NEWMAR CORPORATION WARRANTY DEPARTMENT

TECHNICAL SERVICE BULLETIN							
DATE ISSUED		MODEL YEAR(S) AFFECTED		MODEL(S) AFFECTED		TSB #	
6/12/08		2008		All Class A on Ford Chassis		345	
BRAND						TYPE	
All	<input type="checkbox"/>	Canyon Star	<input checked="" type="checkbox"/>	Mountain Aire	<input type="checkbox"/>	All	<input type="checkbox"/>
Cypress	<input type="checkbox"/>	Dutch Star	<input type="checkbox"/>	Kountry Aire	<input type="checkbox"/>	T T	<input type="checkbox"/>
Northern Star	<input type="checkbox"/>	Kountry Star	<input type="checkbox"/>	Essex	<input type="checkbox"/>	F W	<input type="checkbox"/>
Grand Star	<input checked="" type="checkbox"/>	King Aire	<input type="checkbox"/>	London Aire	<input type="checkbox"/>	C A	<input checked="" type="checkbox"/>
All Star ME	<input type="checkbox"/>	Ventana	<input type="checkbox"/>	Bay Star	<input checked="" type="checkbox"/>	D P	<input type="checkbox"/>
<input checked="" type="checkbox"/> Air Conditioning & Heating		<input type="checkbox"/> Electrical Components

SERVICE BULLETIN

SUBJECT: Water leaks in passenger area

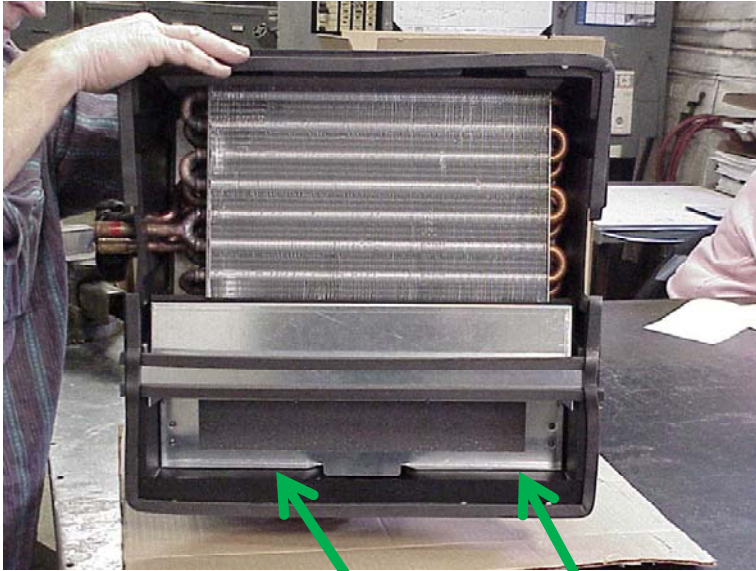
We have received sporadic reports of water coming in through the return air grill on certain Class A Motorhomes, misting the carpet and passengers' feet/leg area. We have determined that this may be the result of an increased amount of ram air due to a more open front cap re-design pushing condensation through the base heater a/c unit when the fresh air door is open and the vehicle is moving. This does not occur in "Max A/C" mode as fresh air is not used and the fresh air door is closed.

In order to eliminate this problem, it is necessary to apply a bead of waterproof sealant to a small gap at the bottom of the firewall mounted heater a/c unit. You will need to access this from inside the coach, through the recirculation opening near the passenger's feet. Remove the plastic grille covering the opening and remember to replace it when the fix is complete. Do not remove the heater a/c unit from the firewall.
